# Access Compliance Report

## Public Rights-of-Way

### (Curb Ramps)

Intersection ID: 23921	Main Street: LAMPMEADE_LN	Cross Street: PORTRUSH_LN	Location: SW
ADA ID: E66A7CFC0E56	Ramp Type: PerpDiag	Initial Pass/Fail: Fail	Overall Compliance: No
		Severity Score: 8.75

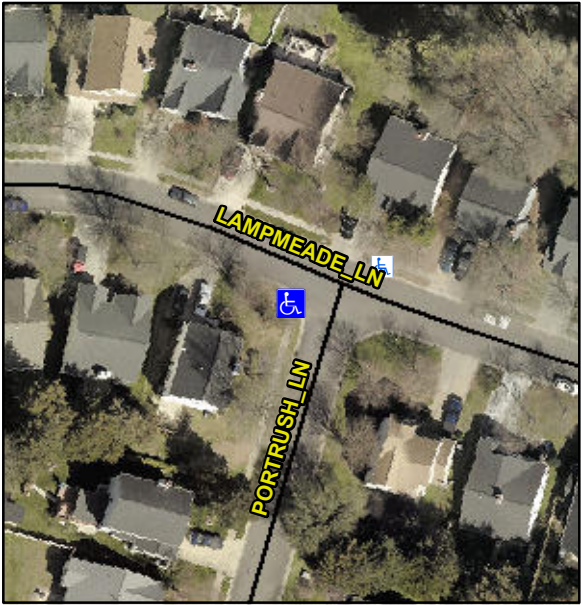
Codes/Mitigation Info/Possible Solution			Field Measurements/Component Compliance			
	Possible Solutions:		<b>Compliance</b>	<b>Description</b>	<b>Data</b>	
	<b>Remove &amp; Replace Curb Ramp With Two New Directional Ramps or Equivalent.</b>		N/A	Ramp Length (in)	95.0	<b>Yes</b>
			No	Ramp Width (in)	47.0	<b>Yes</b>
			N/A	Flare Type LT	N/A	N/A
			N/A	Flare Slope LT (%)	N/A	N/A
			N/A	Flare Traversable LT?	N/A	N/A
			N/A	Landing Length (in)	N/A	N/A
			N/A	Landing Width (in)	N/A	N/A
			N/A	Landing Slope (%)	N/A	N/A
			N/A	Landing X Slope (%)	N/A	N/A
<p>Surveyor Notes:</p> <p><b>N/A</b></p> <p>PROW/ADA:</p> <p><b>Not Found, R304.5.1</b></p>			N/A	Flare Type RT	N/A	N/A
			N/A	Flare Slope RT (%)	N/A	N/A
			N/A	Flare Traversable RT?	N/A	N/A
			N/A	DWS Provided?	N/A	N/A
			N/A	DWS Contrast?	N/A	N/A
			N/A	DWS Length (in)	N/A	N/A
			N/A	DWS Full Width?	N/A	N/A
			N/A	DWS Offset (in)	N/A	N/A
			N/A	Gutter Ponding?	N/A	N/A

N/A	Gutter Lip Ht (in)	N/A	N/A
			N/A	Painted X Walk1?	No	N/A
				X Walk 1 Direction	To SE	
			N/A	X Walk 1 Width (in)	N/A	N/A
				X Walk 1 Slope (%)	0.5	
				X Walk 1 X Slope (%)	0.0	
			N/A	Ramp inside XWalk1?	N/A	N/A
				Road Slope (%)	1.0	N/A
				Road X Slope (%)	0.8	N/A
			N/A	Any Obstructions?	N/A	N/A
				Obstruction Type		
Total Cost: \$ 3200.00					N/A	N/A
					Yes	Surface Condition? (G/P) Good
